MEMORANDUM

To: Montgomery Township Planning Board

Re: **BPS Development Company, LLC**
Preliminary and Final Major Site Plan and Bulk Variances
Major Site Plan 2
Hartwick Drive & Village Drive
Block 28003, Lot 211
ARH Age Restricted Housing Zone

Date: March 23, 2023

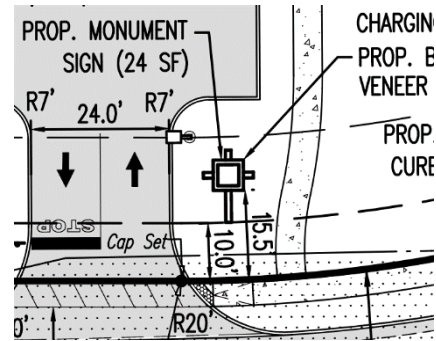
- 6.1. **Proposed Lighting.** Two types of lighting are proposed. The first is a pole-mounted light fixture the is 14-feet in height. The second is a wall/building mounted light that is 12-feet in height. The following table provides additional details about the lights, including location and quantity. **Sheet 10 (Lighting Plan) has been revised to add an additional bollard light type proposed within the interior courtyard.**

Table 4: Proposed Lighting					
Name	Style of Light	Location	Color Temp.	Mounting Height	Quantity
A-1	Pole Mounted	Perimeter of parking area on the opposite side of building	<u>3,000K</u>	14-feet	9
W-1	Building/Wall Mounted	Around the outer perimeter of the proposed building	<u>3,000K</u>	12-feet	22
<u>B-1</u>	<u>Bollard</u>	<u>Courtyard</u>	<u>4,000K</u>	<u>3-feet</u>	<u>4</u>
